Town of Kittery Planning Board Meeting September 14, 2023

ITEM 1—120 US Route 1—Site Plan — Preliminary Review

PROJECT INTRODUCTION

GENERAL NOTES
SCALE: NOT TO SCALE
PROJECT NO: NEX-2200380
2 OF 18

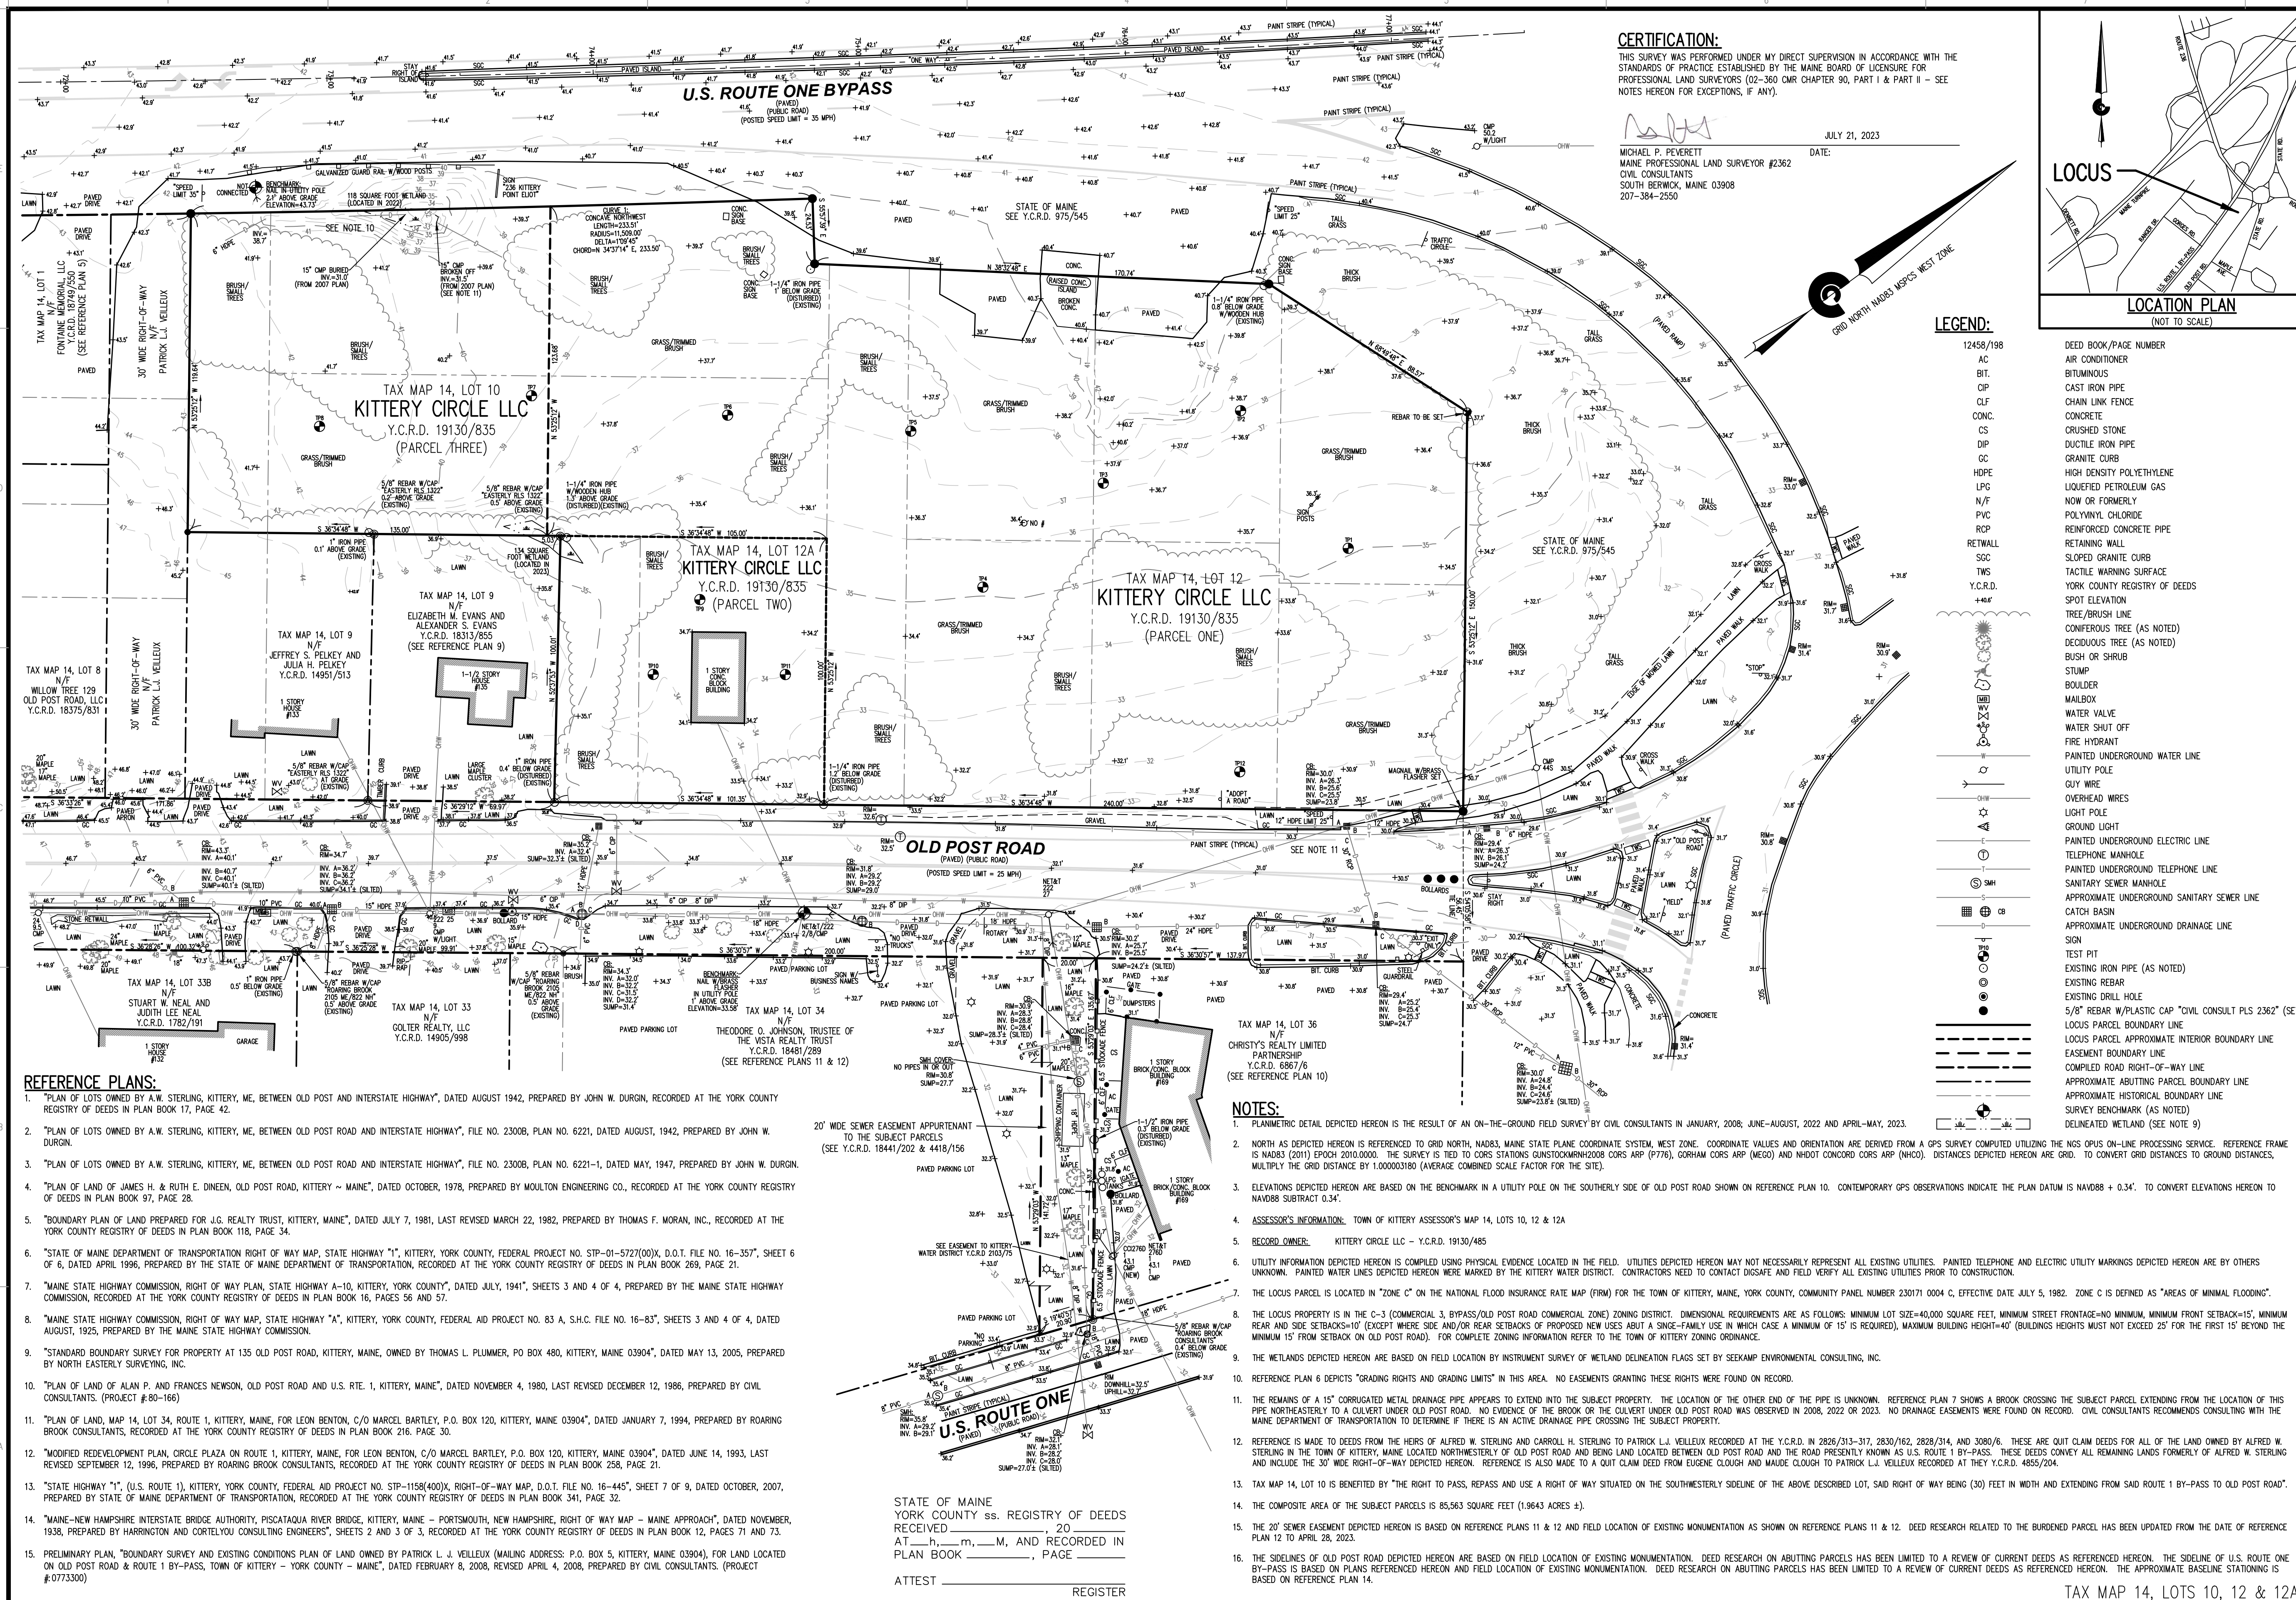
1. Under site plan notes, note 17 lists two requested modifications from the planning board. Has the applicant applied for waivers and or variances? What is the requested reduction for the planter strip? Sheet 6 indicates a modification for the total number of parking spaces is also desired-this should be included in Note 17.

5. Note 8 under Erosion & Sediment Control Plan Notes "by routing equipment to all areas or each layer" should be clarified.
6. Temporary Erosion Control Measures Note 13 references "construction entrances shown on this plan". Please update to Sheet 10.

SITE PLAN

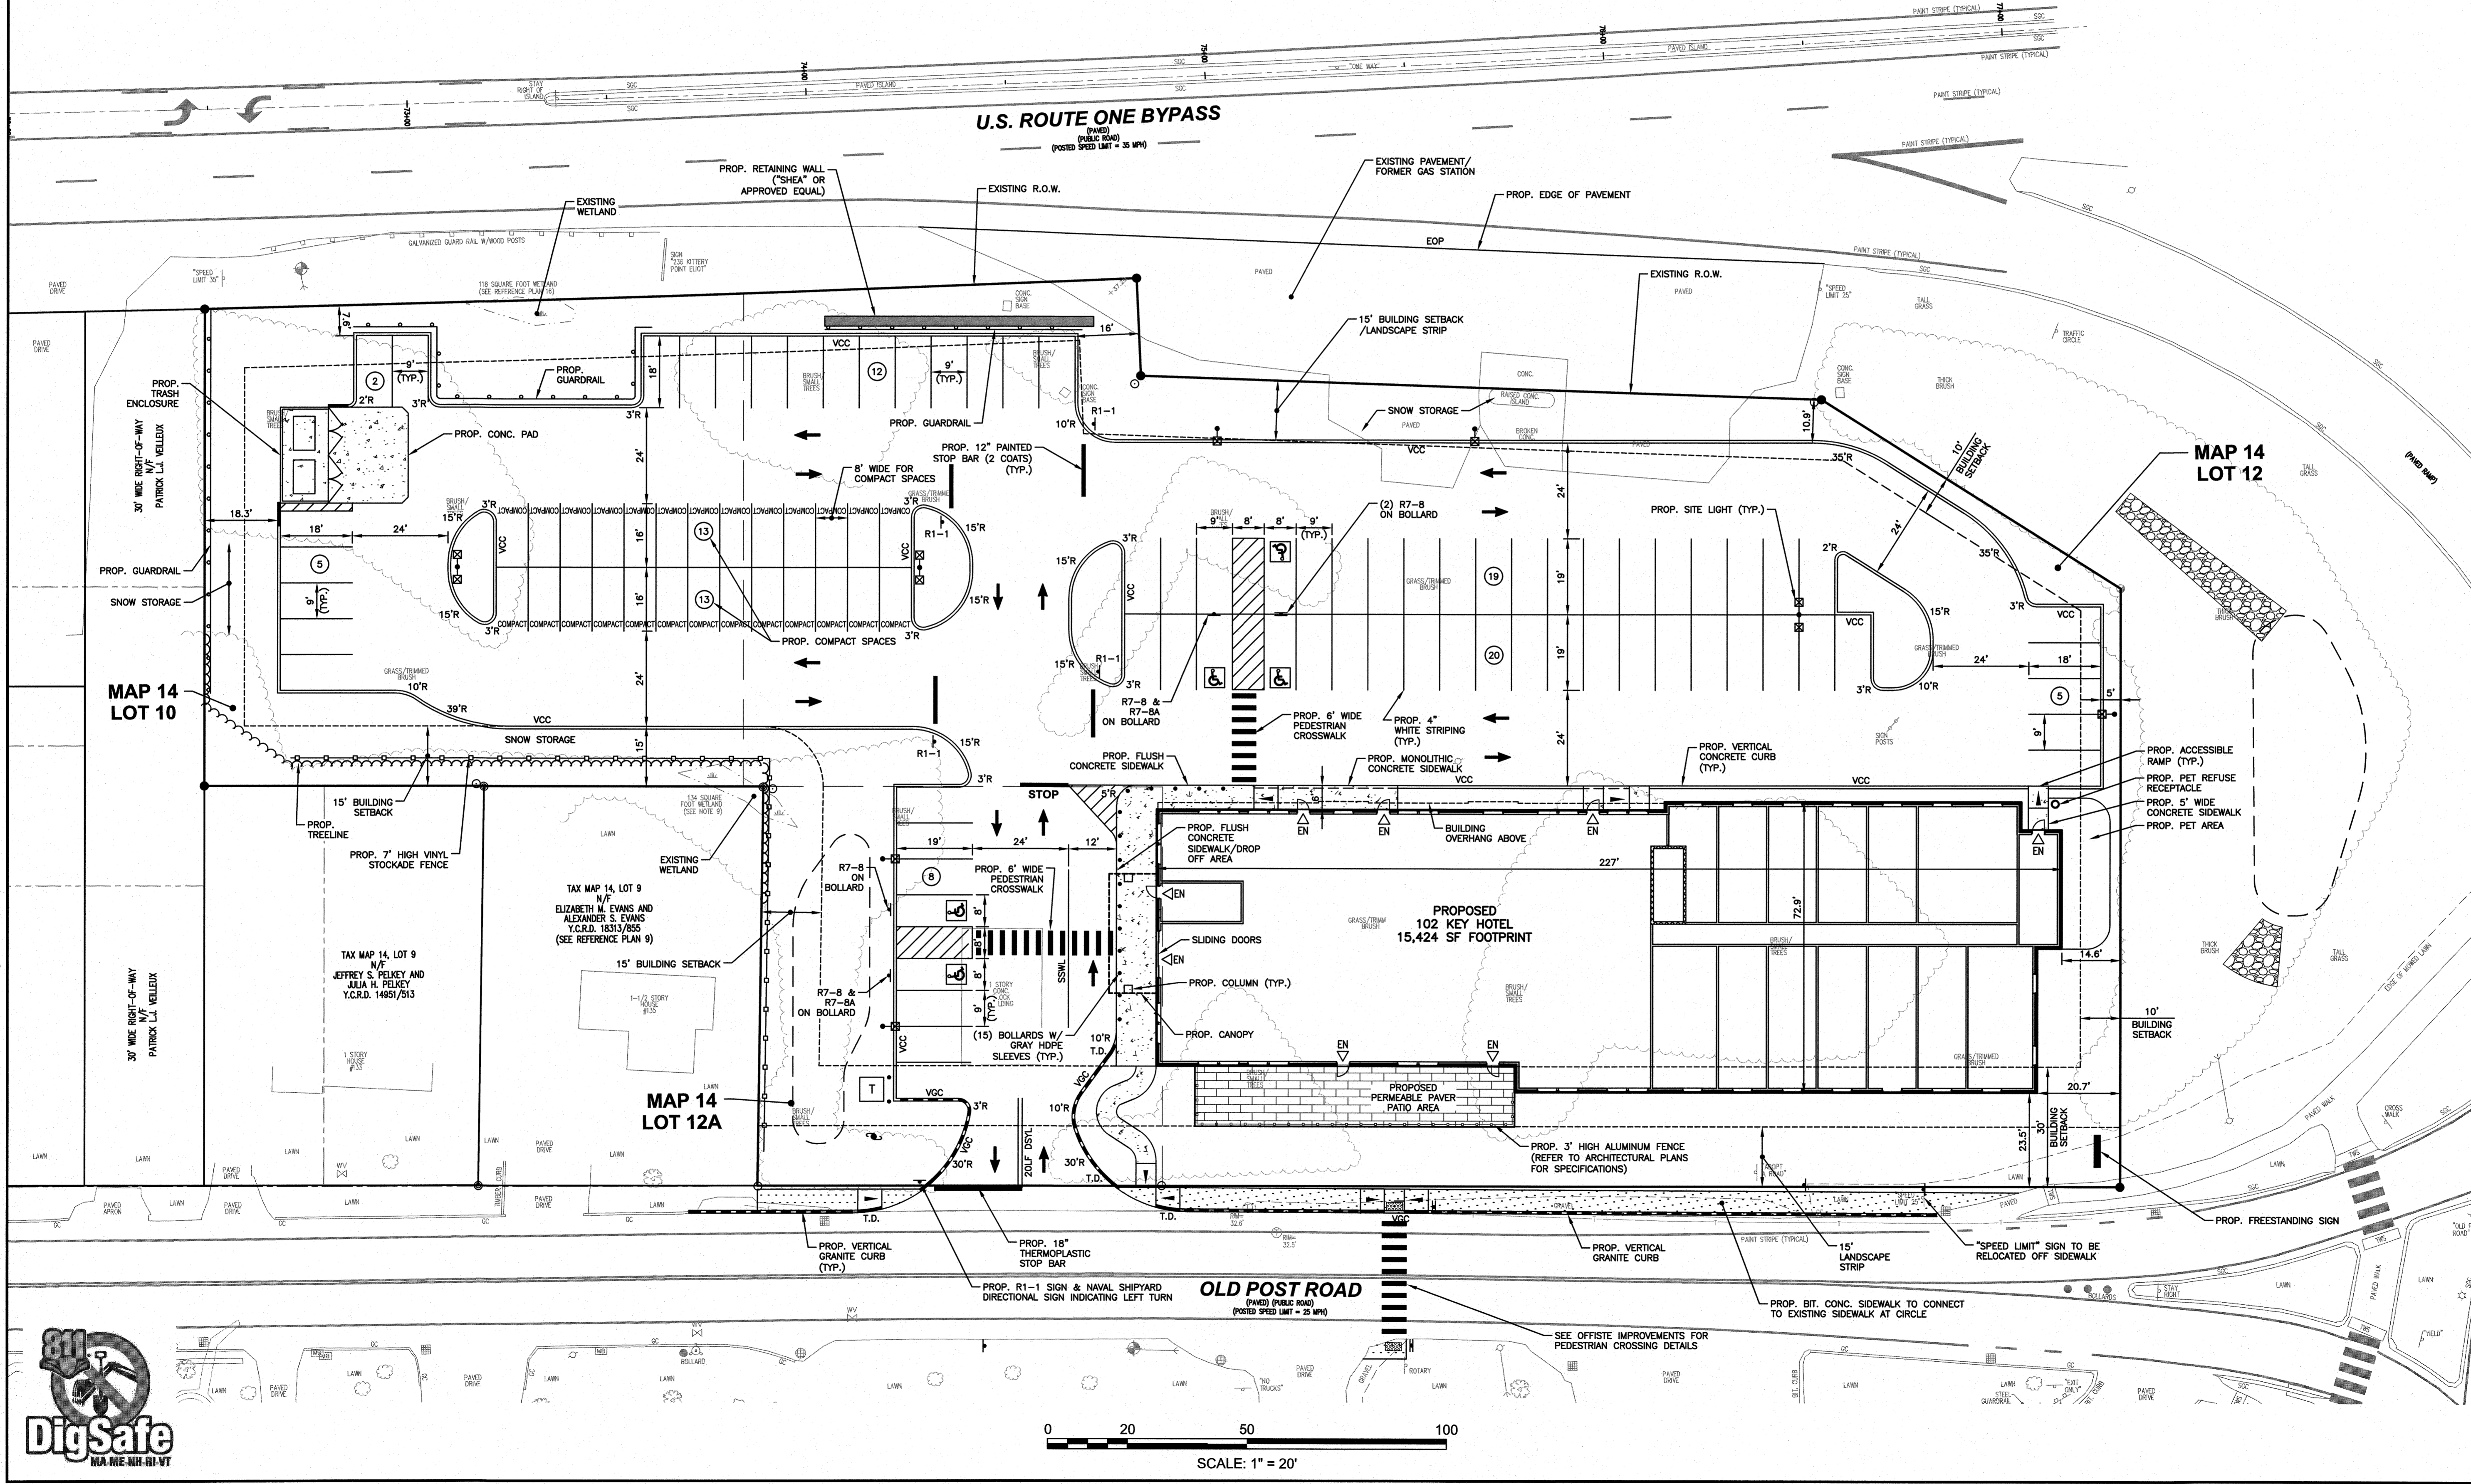
1. As requested by public works and police, the applicant is proposing a crosswalk to connect the driveway of the hotel to the abutting businesses across the street on Old Post Road. The current location on the site plan is tentative and will be determined as a part of the final plan application through coordination between the applicant and DPW.

5. The site plan notates a side yard setback of 14.6 feet. This refers to the portion of the lot facing the Kittery Traffic Circle. The portion abutting residential properties meets the required 15-foot side setback.

10 OF 18

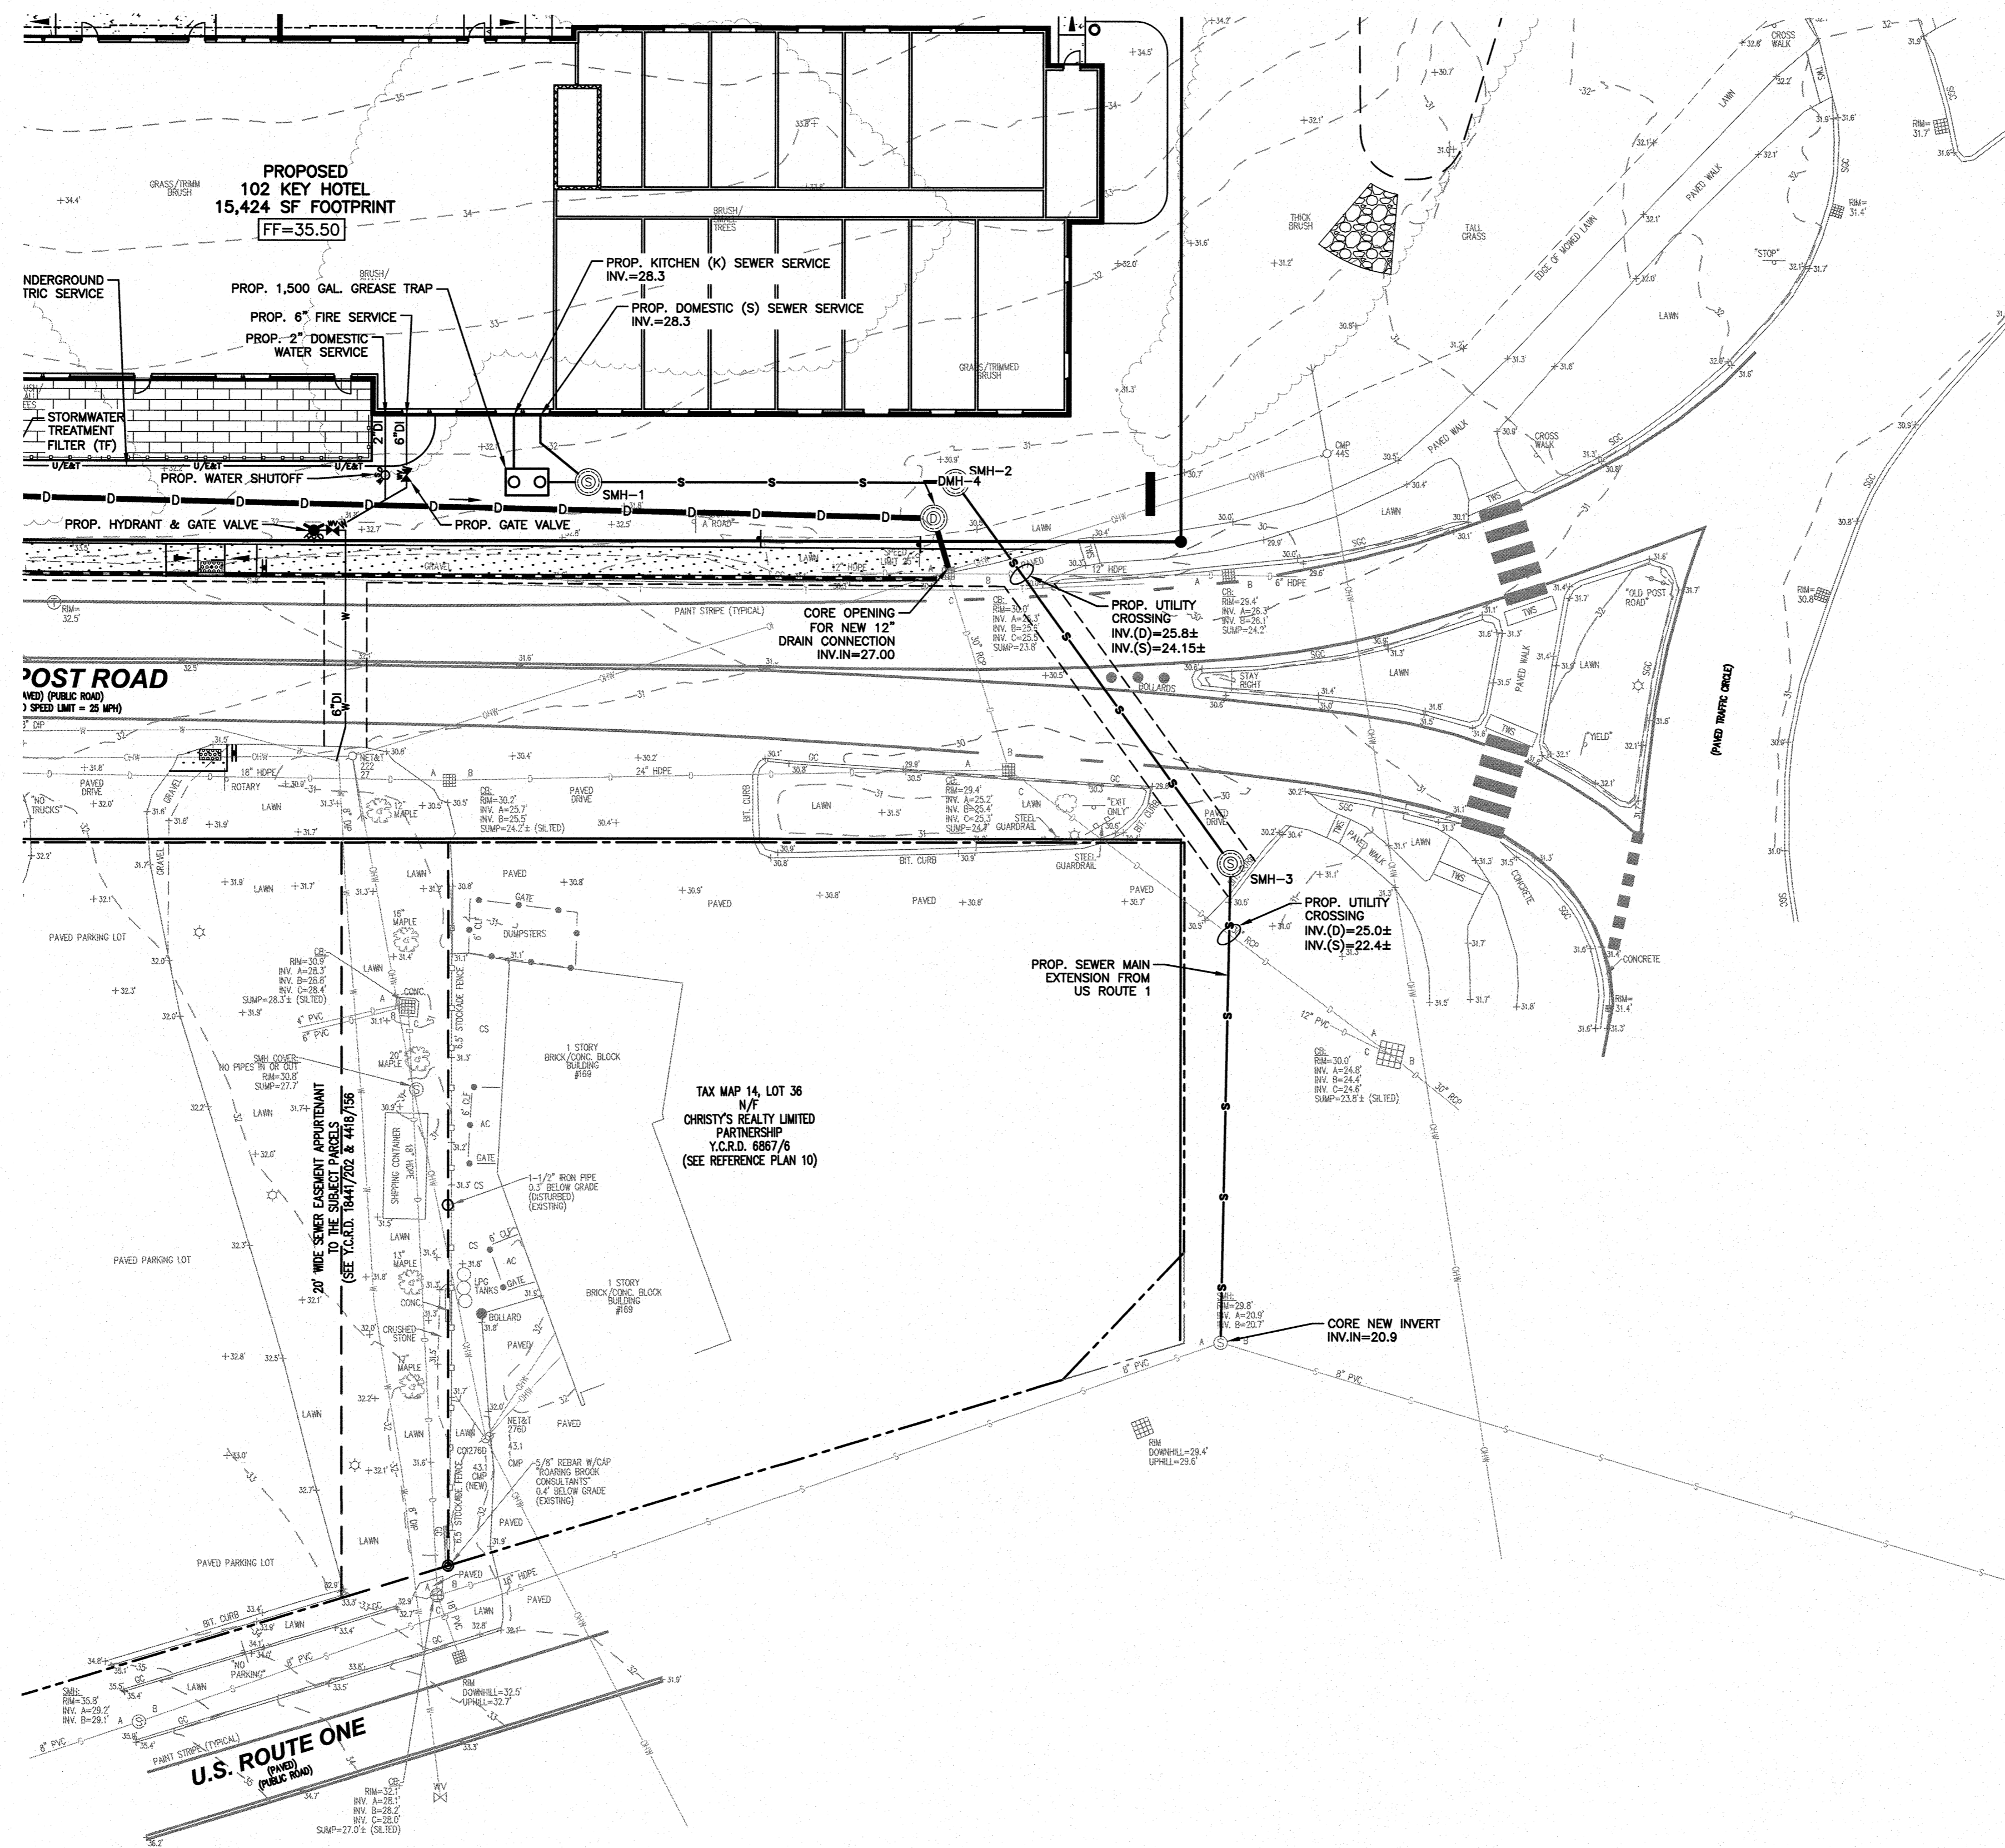
1. The detail is for a 3,000-gallon grease trap but Sheet 10 indicates it is 1,5000 gallons.
2. Water details should be reviewed and approved by Kittery Water District.
3. Sewer details should be reviewed and approved by Kittery sewer services.
